PLAN OF PROPOSED IMPROVEMENT

REVISED BY EEA 8/17/2023

CITY PROJECT NO. 14343
CONTRACT NO. 9217

SOUTHERN ADDITION TO BIRCHWOOD POINT - PHASE 6

14343	MADISON, WI	9217	P-5
PLAN & PROFILE - BIKE PATH		CONTRACT NO.:	
SOUTHERN ADDITION TO BIRCHWOOD POINT - PHASE 6		14343	
M:\DESIGN\Projects\14343\CAD\Streets\14343EN-PrP2.dwg			
14343		P-5

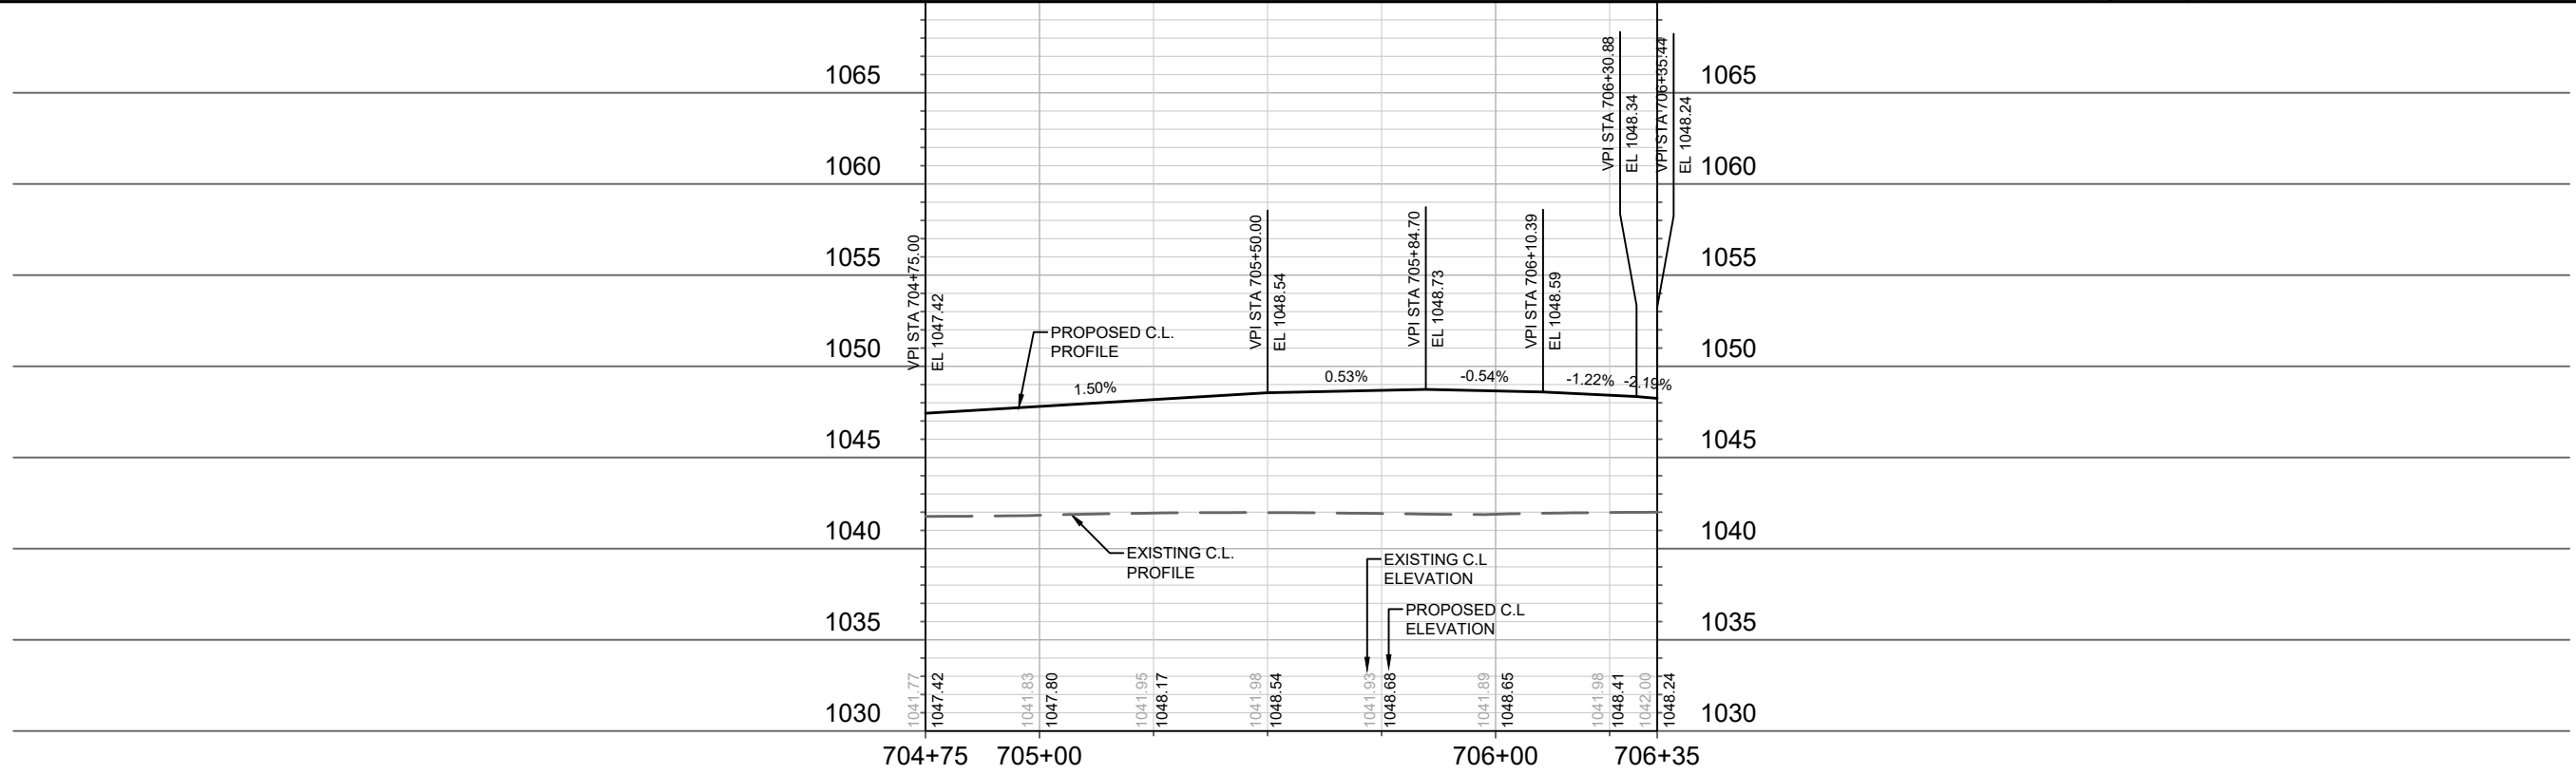
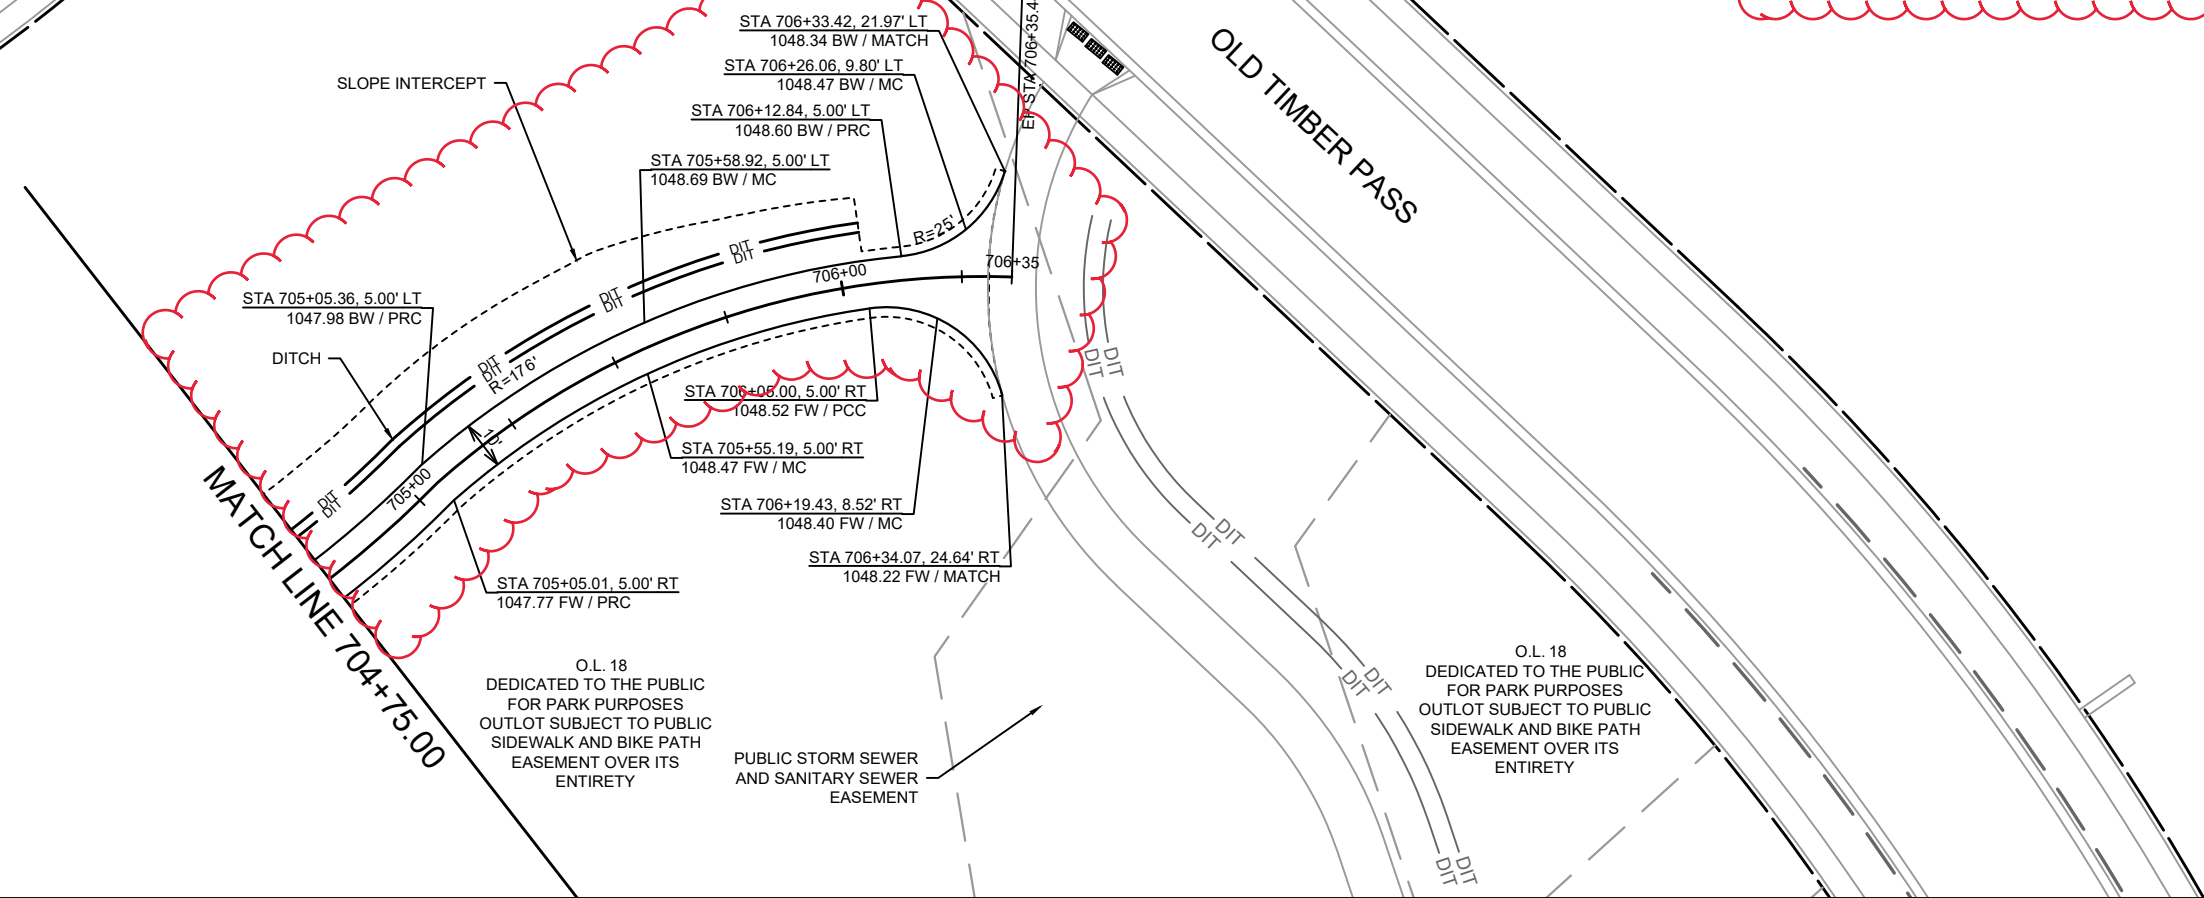
REVISED BY EEA 8/17/2023
 1. REMOVED NOTE 1
 2. UPDATED 10' ASPHALT PATH DITCH AND SLOPE INTERCEPT
 3. ADDED SLOPE INTERCEPT AND DITCH LABELS

PLAN & PROFILE - PARK SWALE
SOUTHERN ADDITION TO BIRCHWOOD POINT - PHASE 6
M:\DESIGN\Projects\14343\CAD\Streets\14343EN-GradingPnP.dwg

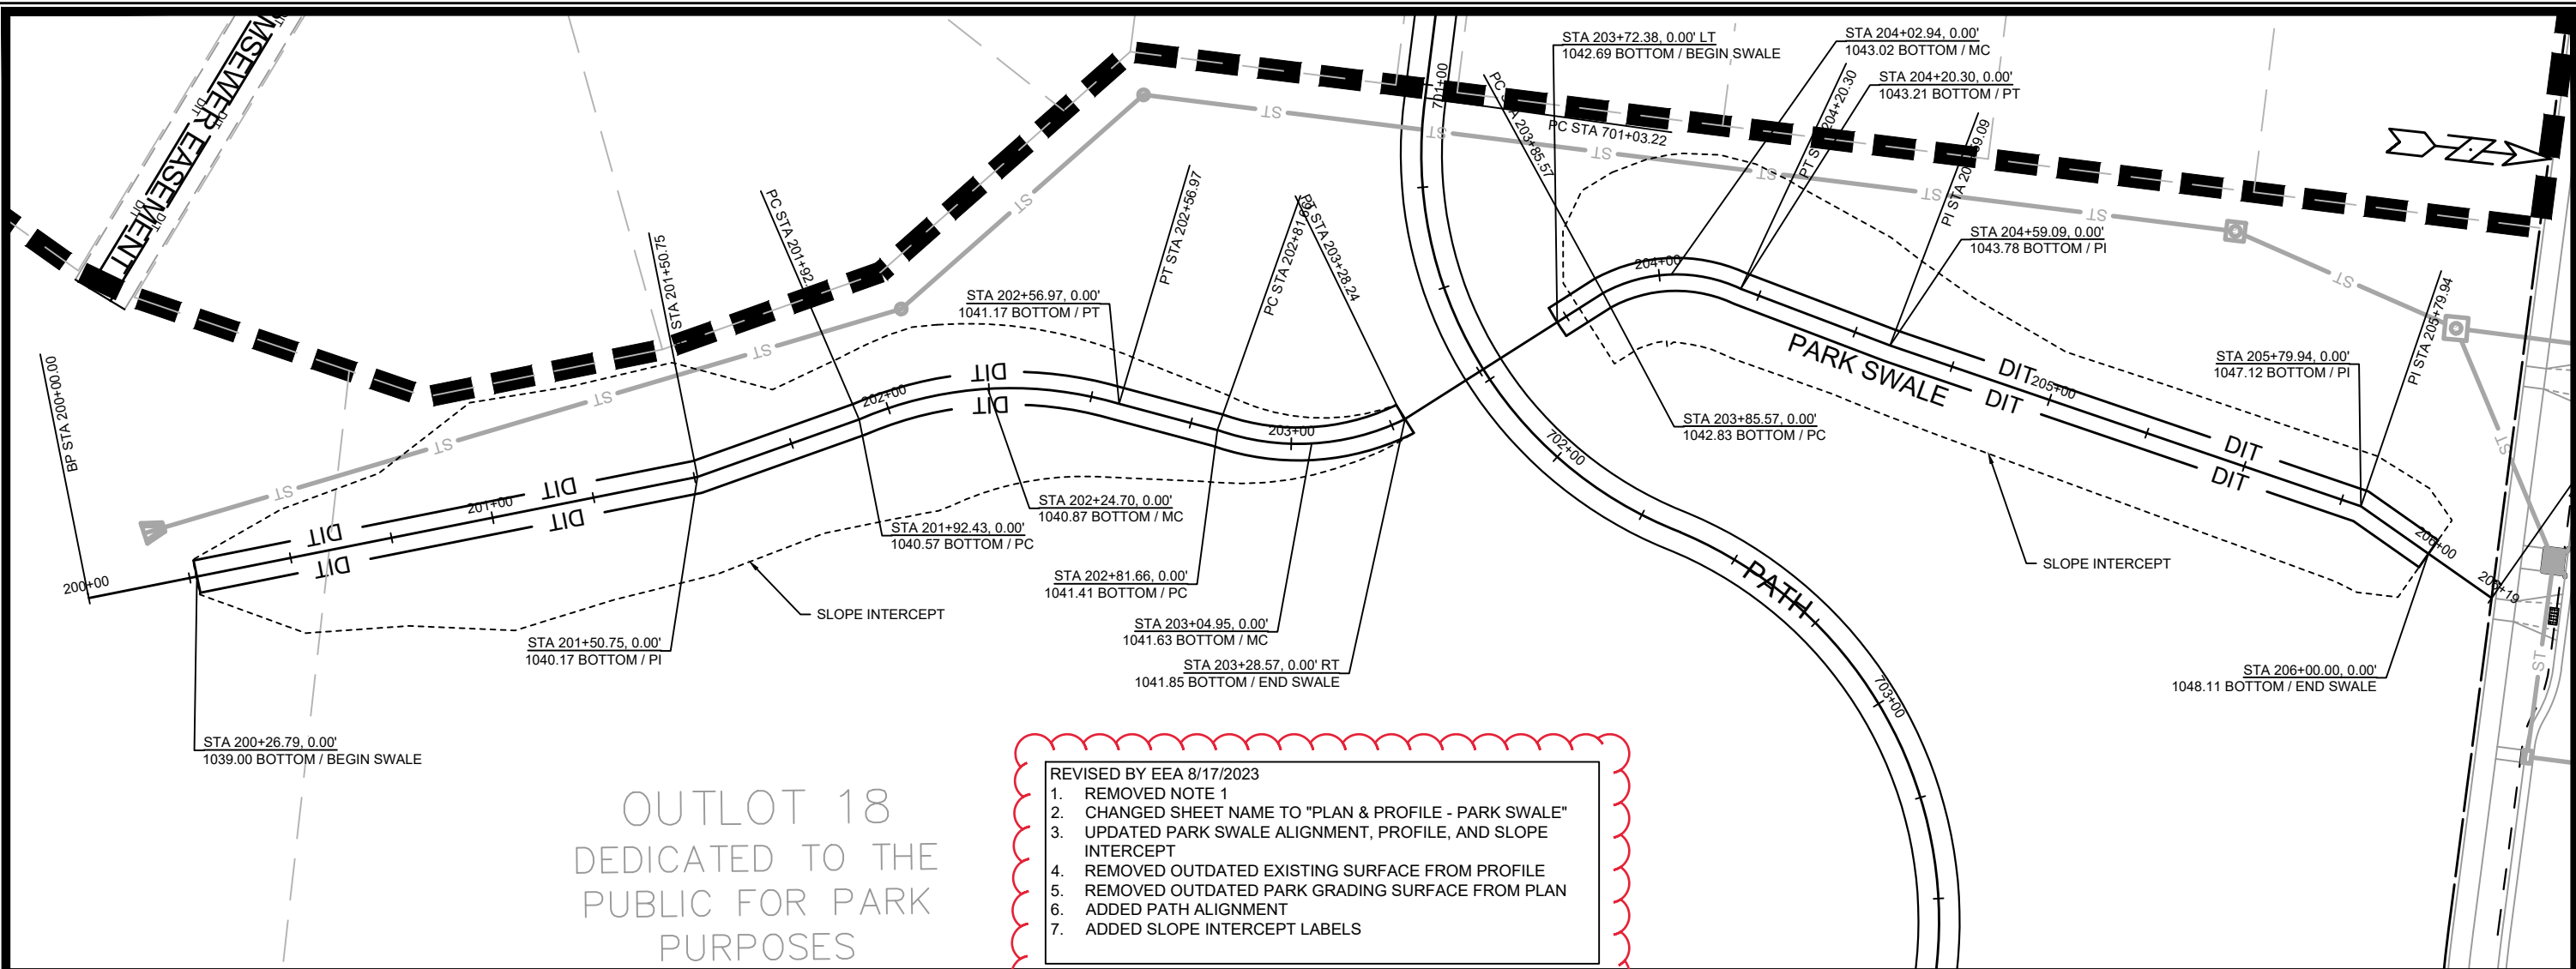
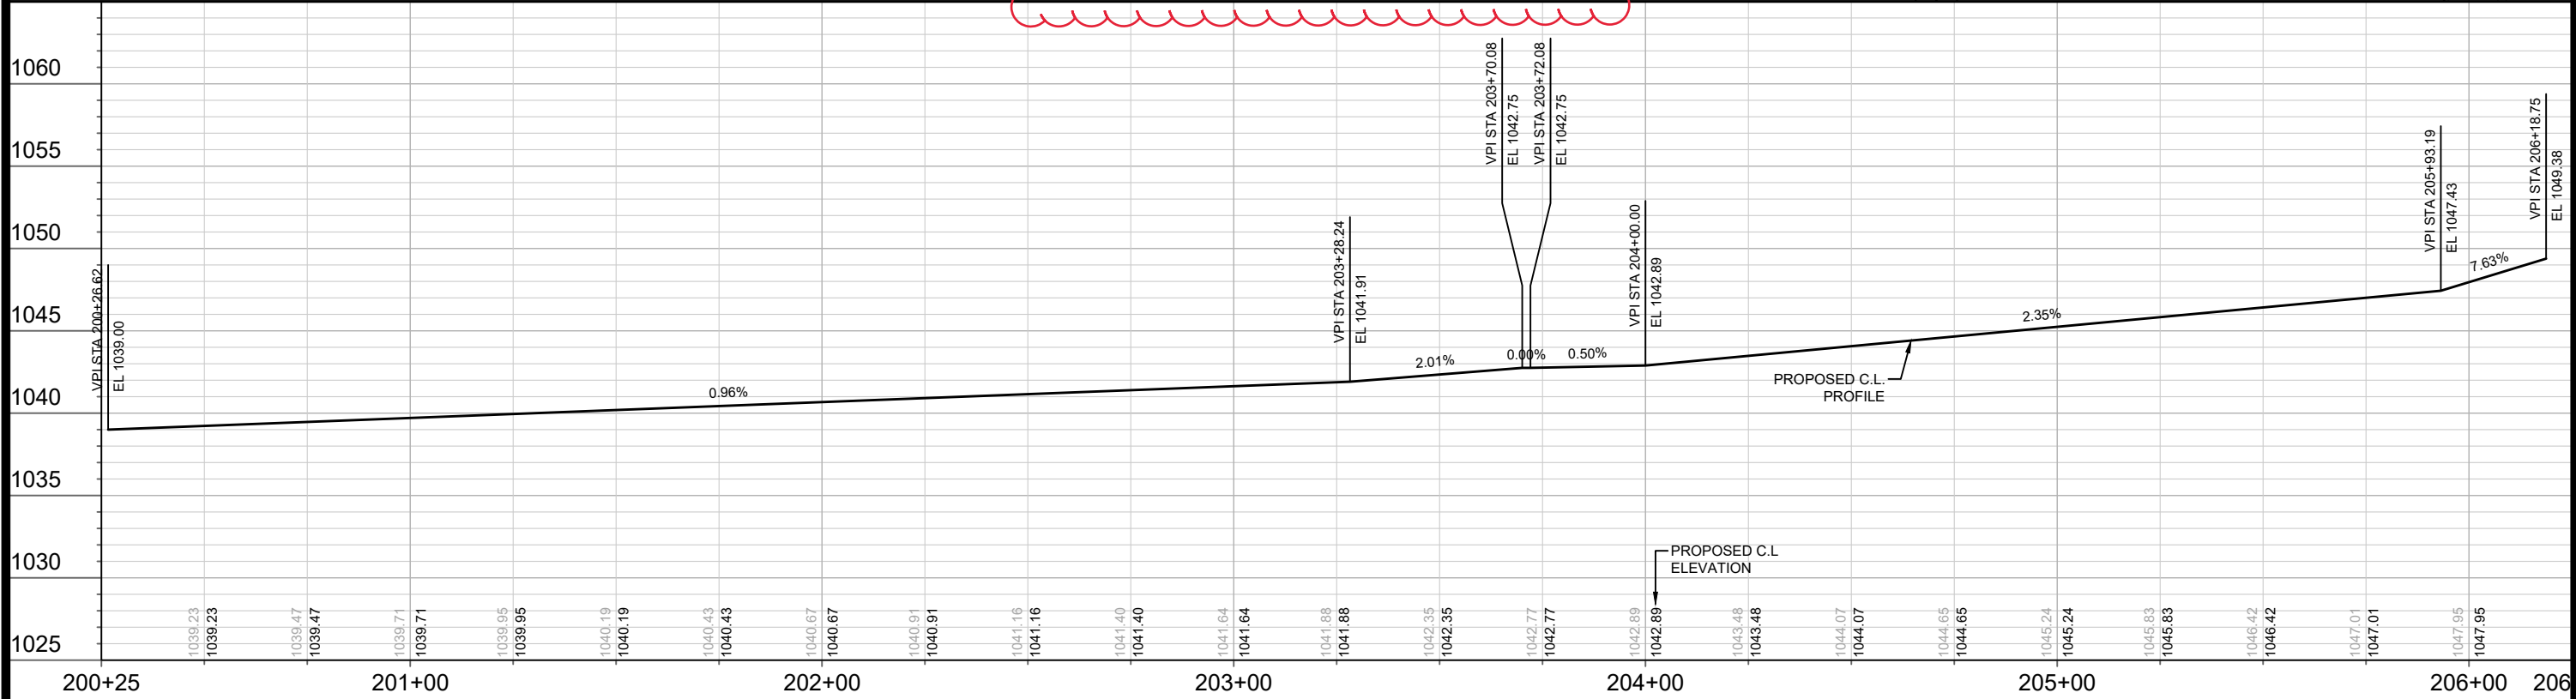
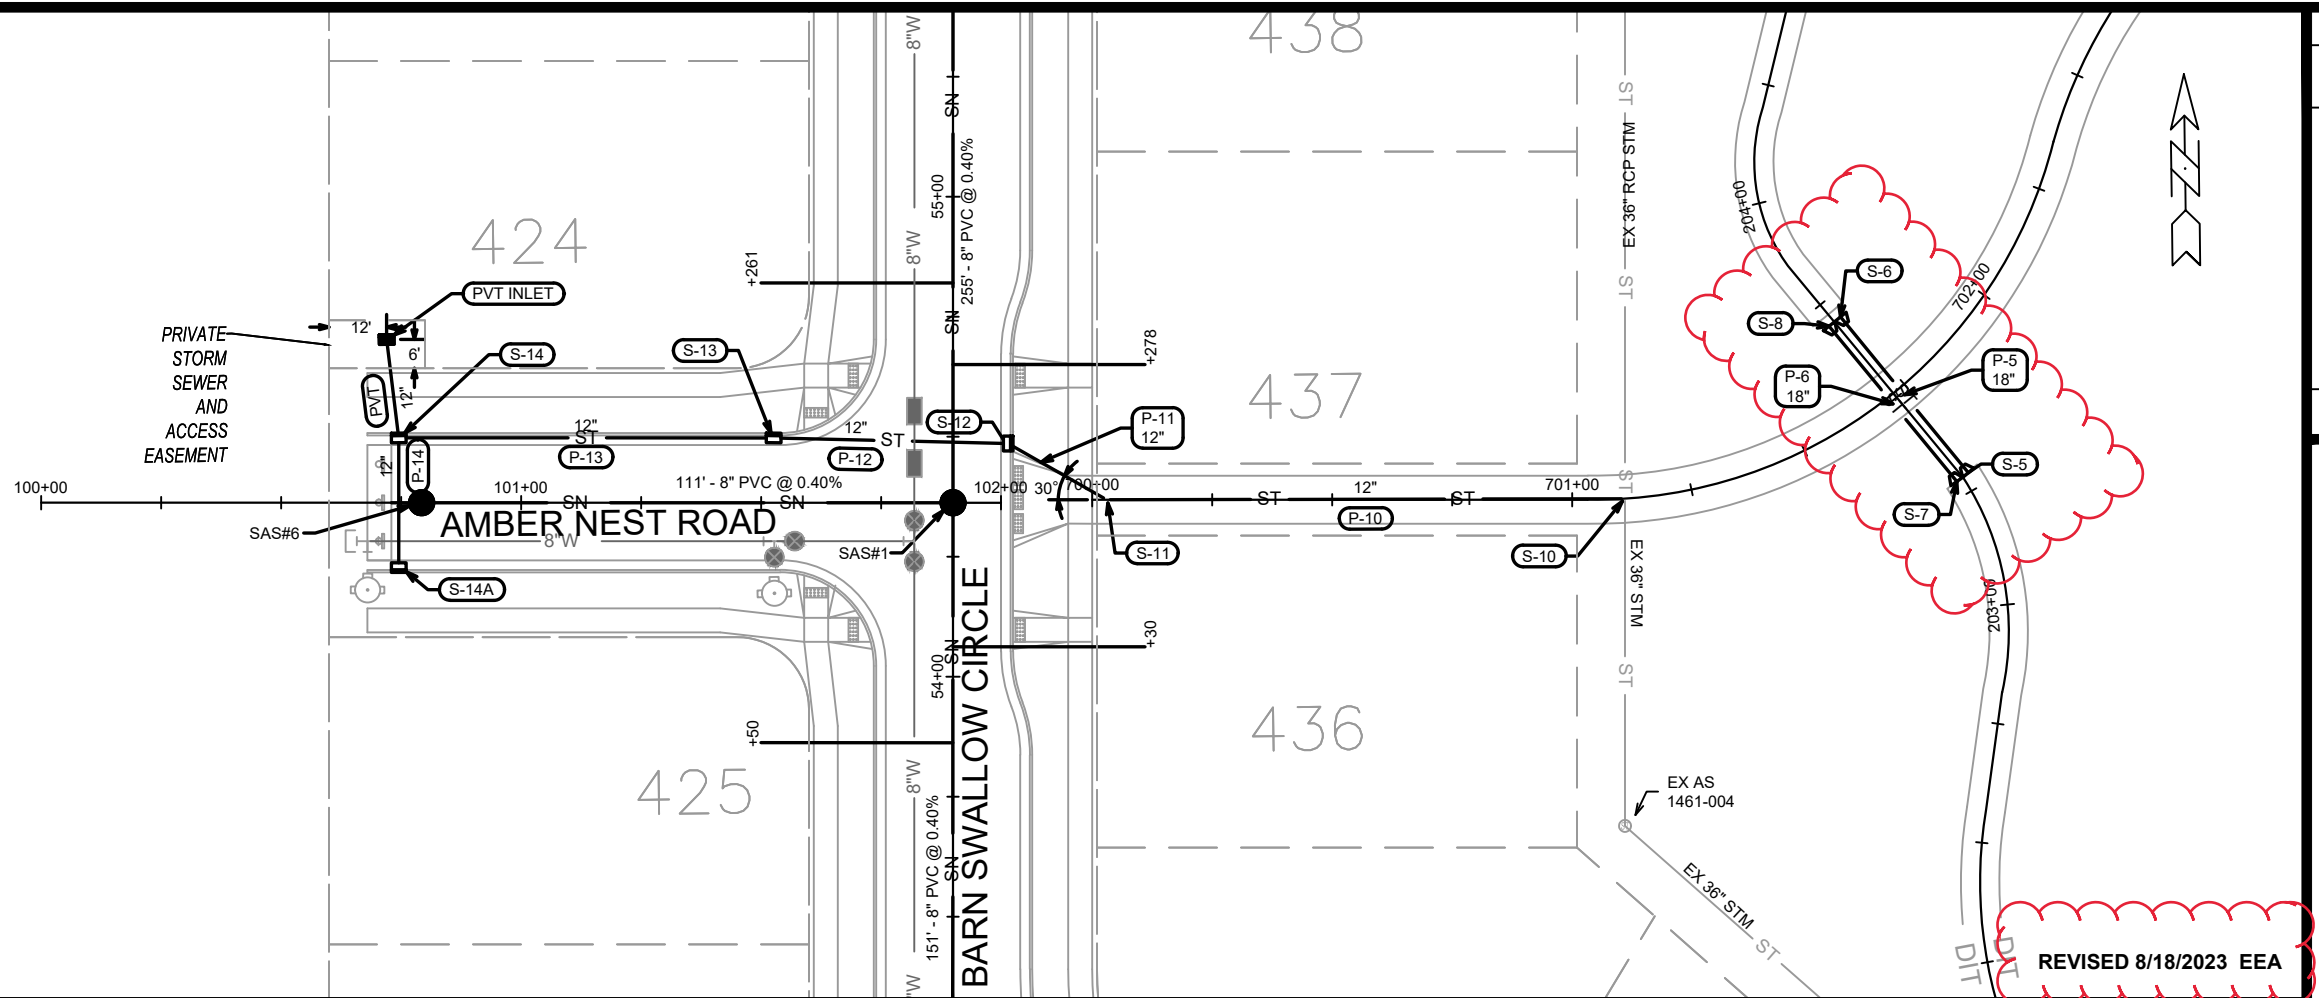
REVISED BY EEA 8/17/2023
 1. REMOVED NOTE 1
 2. CHANGED SHEET NAME TO "PLAN & PROFILE - PARK SWALE"
 3. UPDATED PARK SWALE ALIGNMENT, PROFILE, AND SLOPE INTERCEPT
 4. REMOVED OUTDATED EXISTING SURFACE FROM PROFILE
 5. REMOVED OUTDATED PARK GRADING SURFACE FROM PLAN
 6. ADDED PATH ALIGNMENT
 7. ADDED SLOPE INTERCEPT LABELS
